*Date:* September 14, 2023  
*Case No.:* **2019-020115ENV**  
*Project Title:* **Ocean Beach Climate Change Adaptation Project**  
*To:* Members of the Planning Commission and Interested Parties  
*From:* Lisa Gibson, Environmental Review Officer  
*Re:* Responses to Comments on the Draft Environmental Impact Report for the Ocean Beach Climate Change Adaptation Project

RESPONSES TO COMMENTS

# Ocean Beach Climate Change Adaptation Project

Case No. **2019-020115ENV**

**Revised Figure S-3**  
Conceptual Cross Sections of Access Improvements  
Proposed for South Ocean Beach

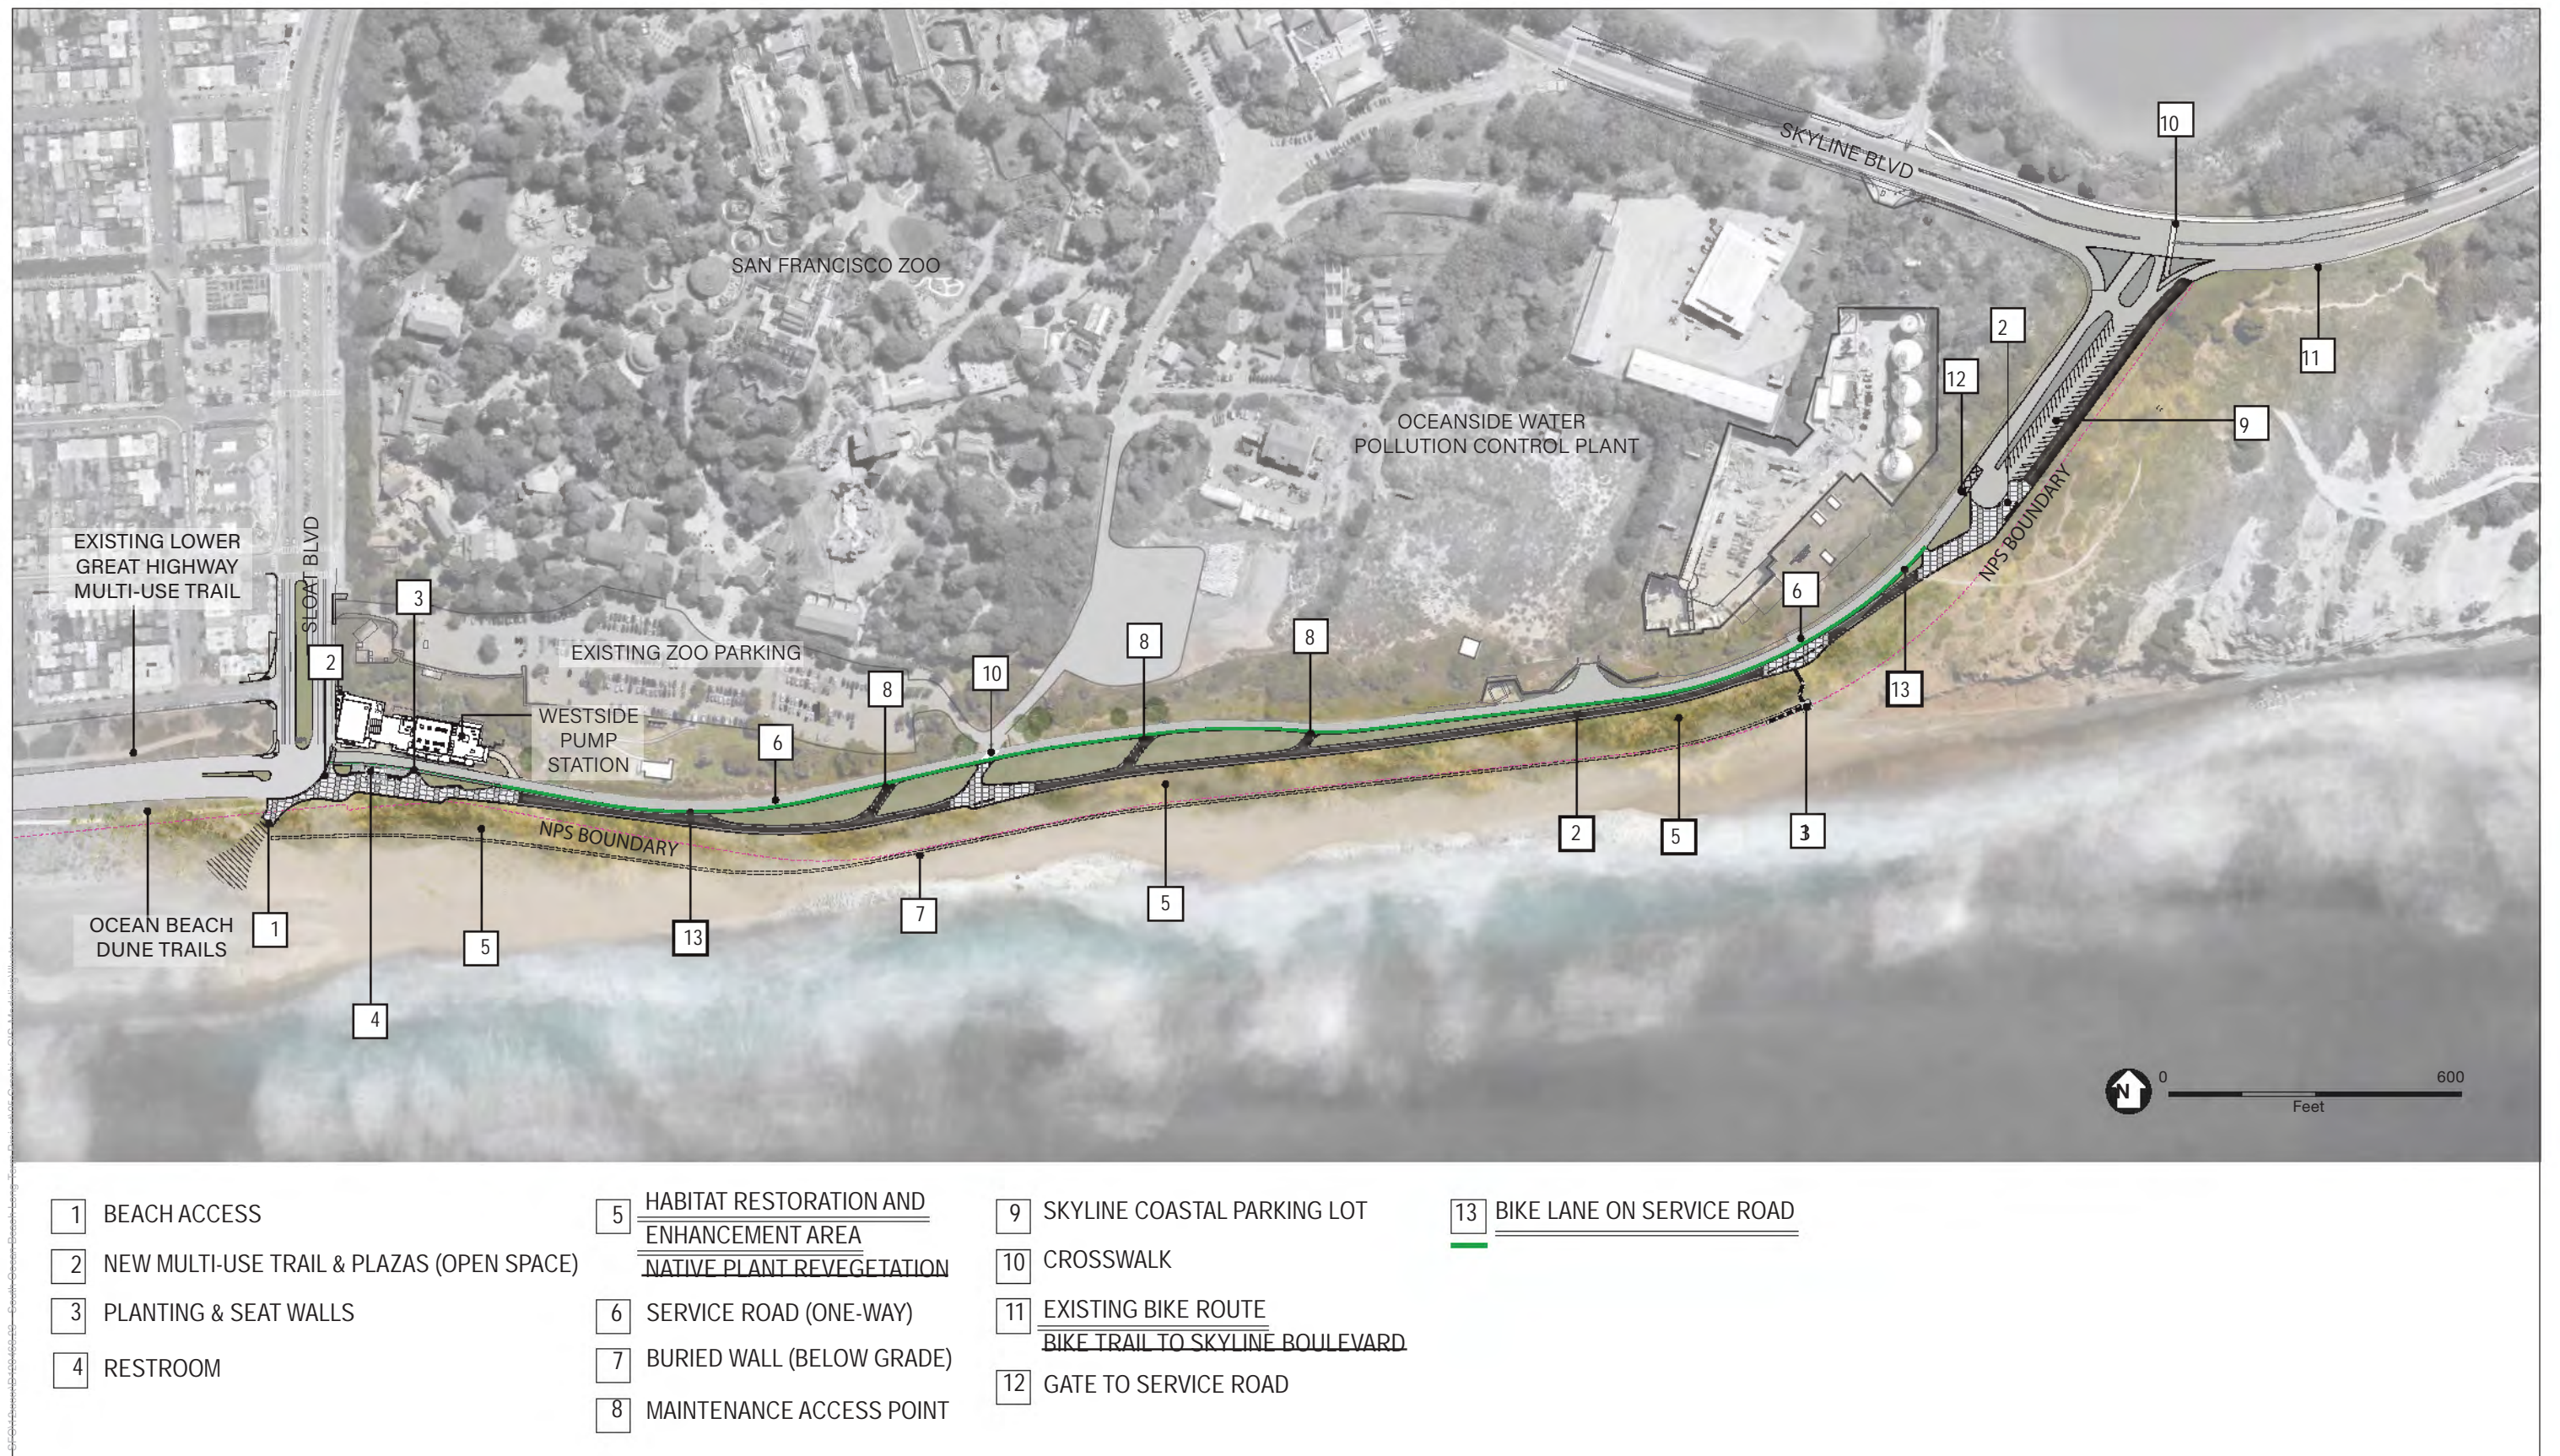
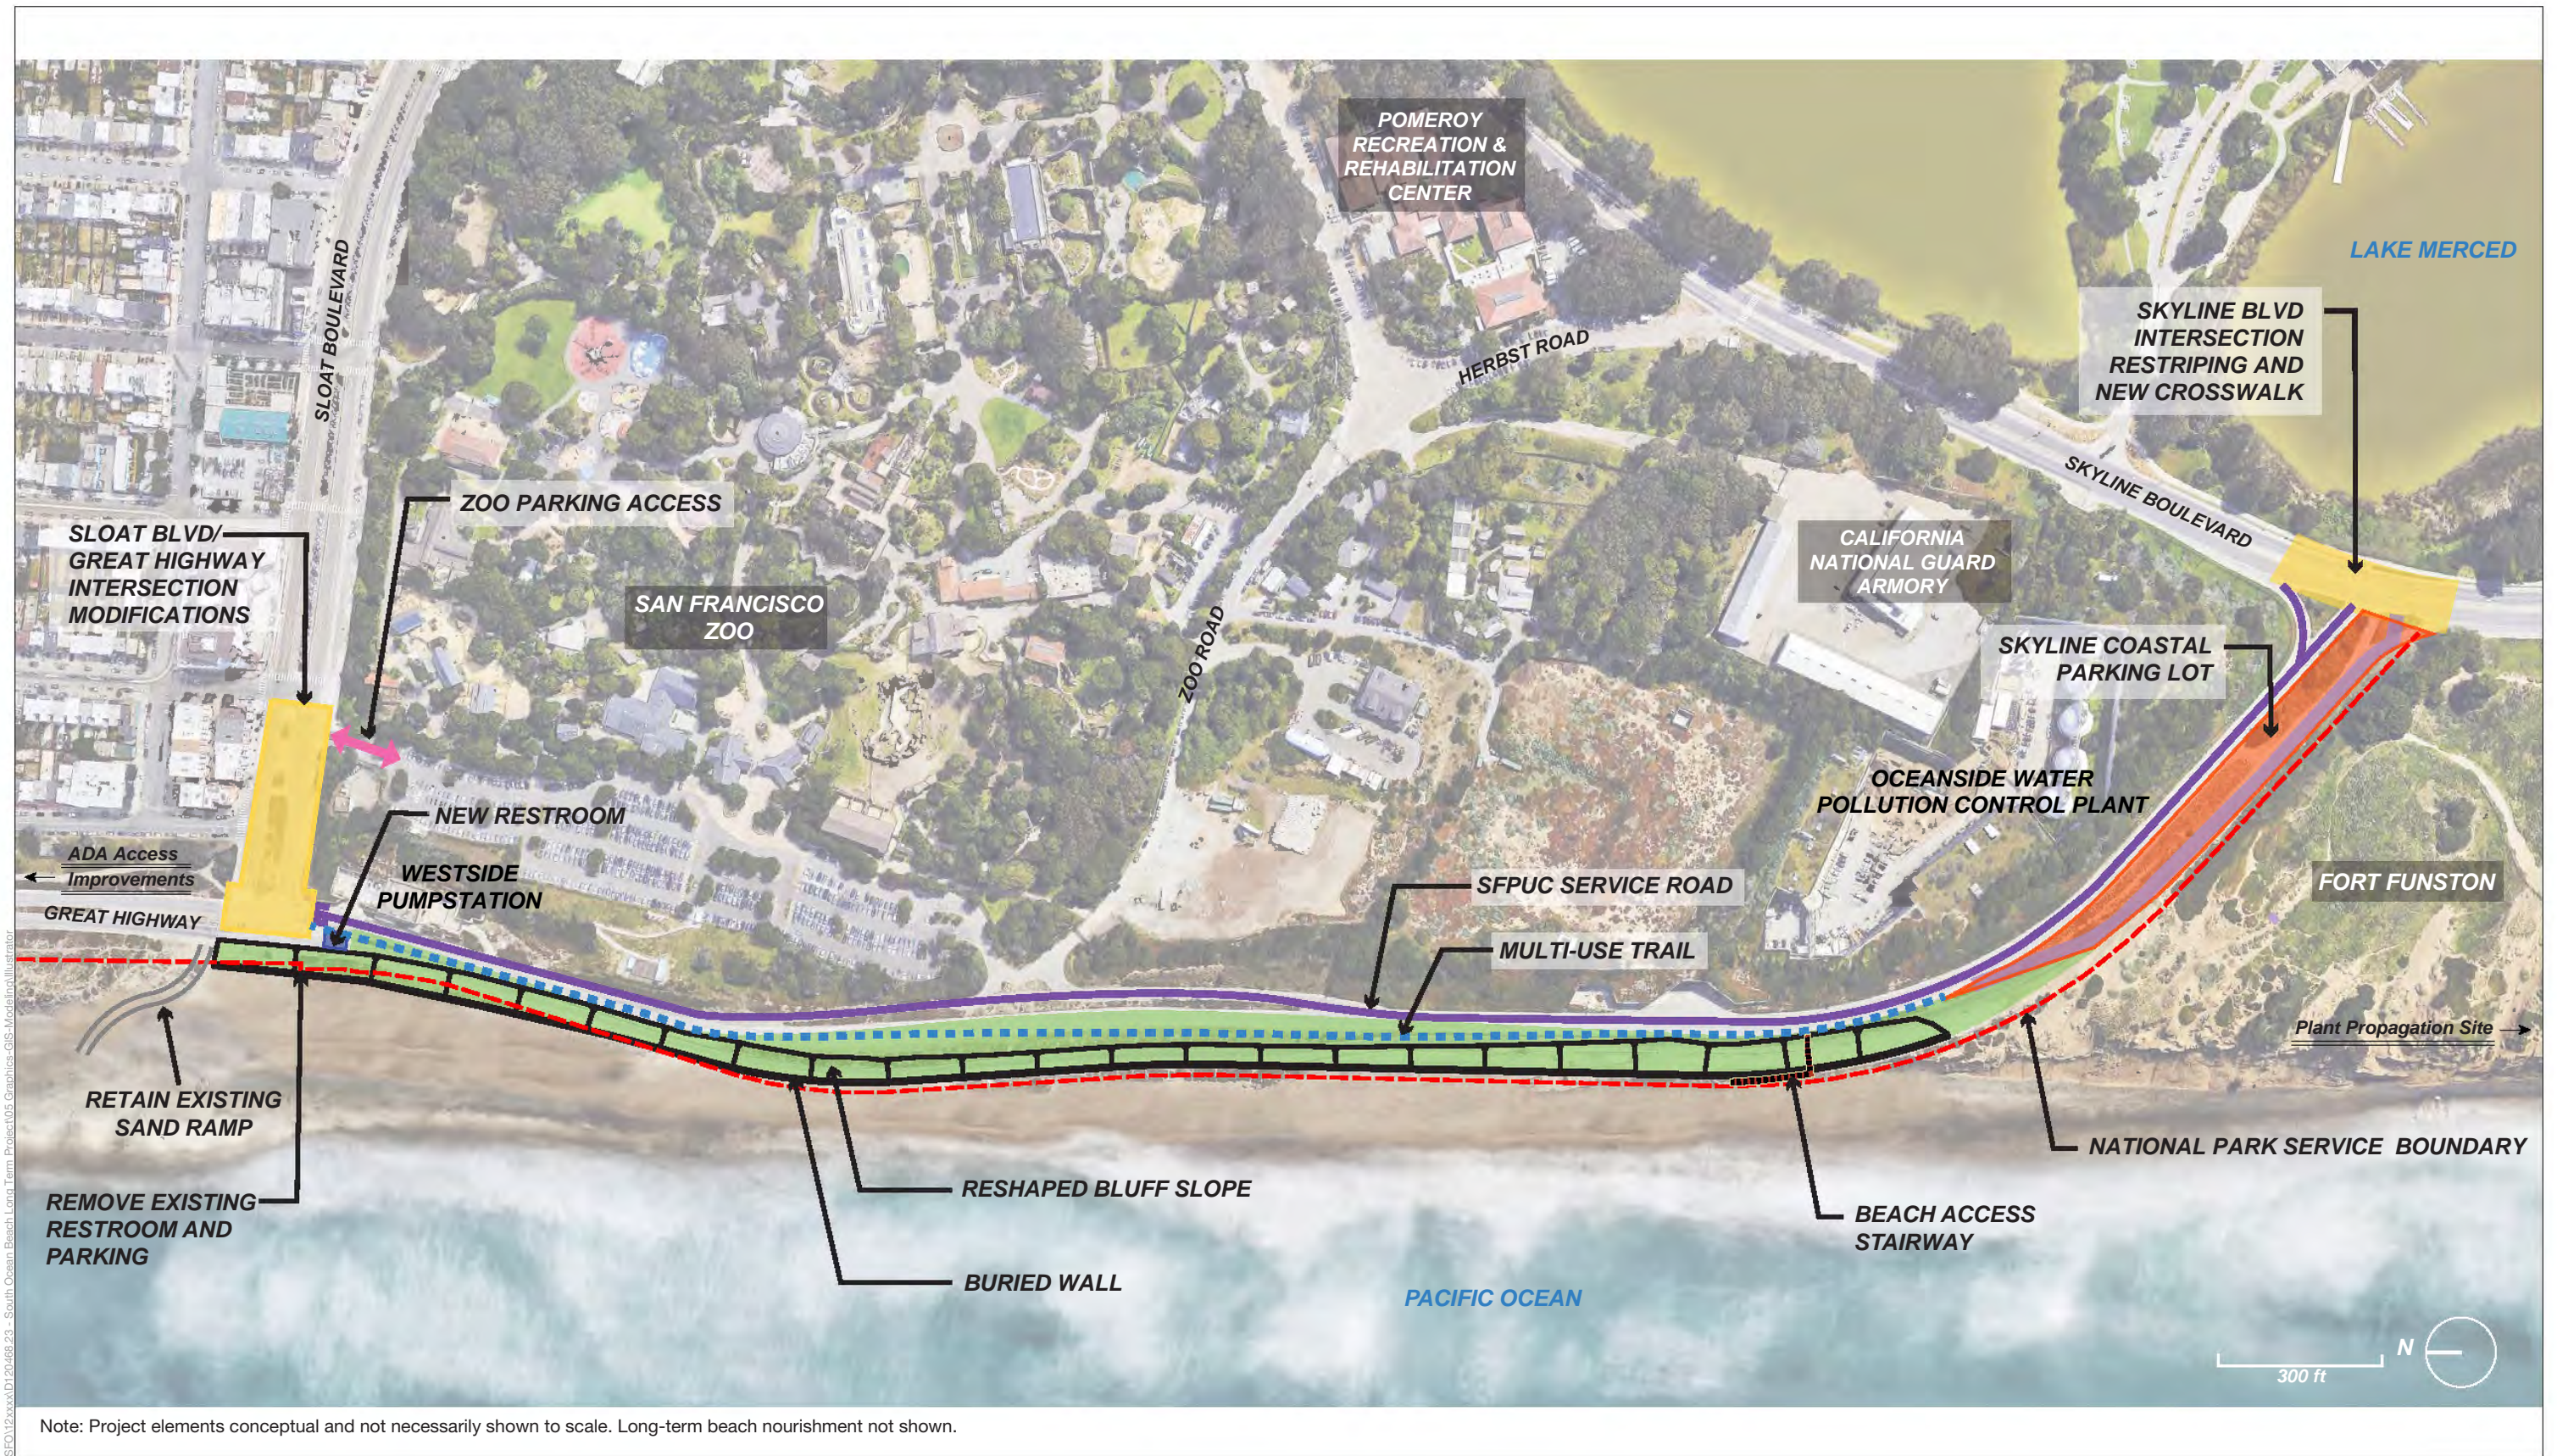
- c. Please provide an explanation as to why the final grade depicted in Figure S-3 (on page S-8) is substantially lower than the original grade and whether the intent of this is to maintain a slope suitable for replanting and/or recreation. If the SSL is meant to be accessible to the public when the sand topping erodes it away, please evaluate an option of making the steps wider and easier to sit/recreate upon.” (Peter Benham, Coastal Planner, California Coastal Commission, North Central Coast District [A-CCC.24])

“So with that, I just wanted to have -- I do have a couple of clarification questions that I would hope would be addressed in the response to comments. The first is that I find figure S-3 which is the same as 2.6 which is the same figure Ms. Moore put up at the beginning of her presentation, is somewhat challenging to read, especially in the EIR. It's very faint, it's hard to tell the dash lines from the straight lines. There's not enough labeling. There's a circular symbol which I assume is the tunnel, but it's not labeled as tunnel. Just sort of simple things that would make it easier for the public to understand. That's a very important cross-section.” (Sue Diamond, Commissioner, San Francisco Planning Commission [A-CPC-1.1])

Regarding the comment's item c), the final grade in draft EIR Figure S-3 is shown as being lower than existing to reflect the slope modifications required in association with constructing the buried wall and slope stabilization layer, and removing the revetment rock, sand bags, and rubble. A landward shift of the shoreline, or "managed retreat" from existing shoreline conditions, can only be accomplished by establishing a final grade that is below and/or landward of existing grade. It is important to note that the figure does not necessarily represent final design, but rather is intended for illustrative purposes to support the EIR's analysis of potential environmental effects. It is possible that a portion of any remnant bluff located seaward of the buried wall may be retained for its incidental shore protection benefits, but reshaped to protect against scarp formation and associated public safety hazards. As noted above, the slope stabilization layer would be buried by sand most of the time, and the sand layer would be expected to evolve into more undulating topography over time as it is shaped by wind. The slope stabilization layer has been designed to support sand placement and planting with native vegetation. It is not intended for recreational use.

In response to the comment (A-CPC-1.1) suggesting changes to draft EIR **Figures S-3 and 2-6**, the text in these figures has been enlarged and the tunnel labeled as shown on the following pages. Also, weight has been added to the dashed lines to increase their visibility. Similarly, in response to the comment (A-CPC-1.3) requesting clarification on the green line shown in draft EIR **Figure 2-2**, the figure has been revised as shown below to include a label identifying the green line as a designated bicycle lane along the service road. Revised Figure 2-2 also updates another label to be consistent with project description revisions in Chapter 9.

The text in **Figure S-3** on draft EIR p. S-7 has been enlarged and the tunnel labeled. Also, weight has been added to the dashed lines to increase their visibility.
